California Regional Water Quality Control Board San Diego Region

**Subject: Notice of Violation No. R9-2011-0025 and Water Code Section 13267
Technical Report, Del Sur/Unit 14 Construction Site**

NOTICE OF VIOLATION

FACILITY INSPECTION REPORT

Figure 7. Location of second breach

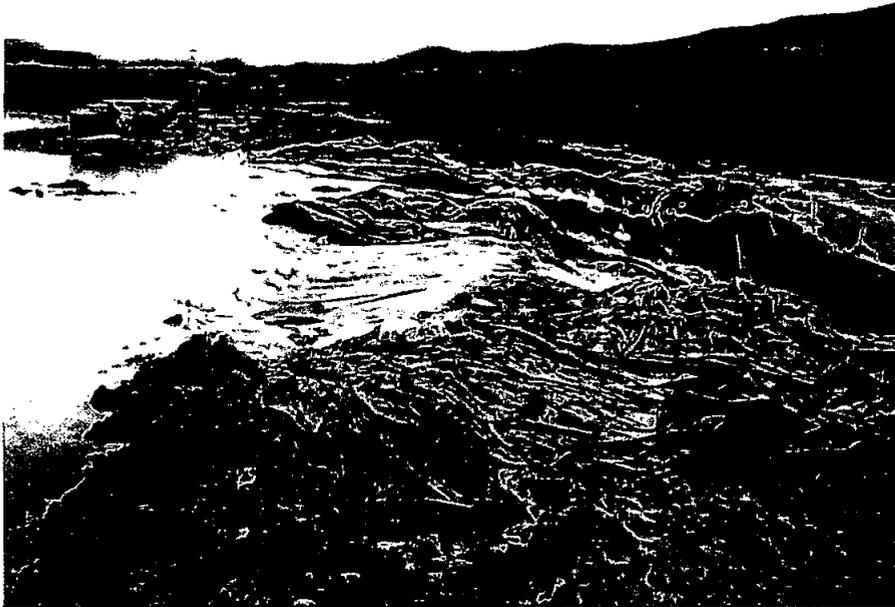
4. The berm at the perimeter that was used to temporarily detain the storm water was overwhelmed by recent storms. Sediment-laden storm water breached the berm in at least two places and entered Lusardi Creek (Figures 4-9).
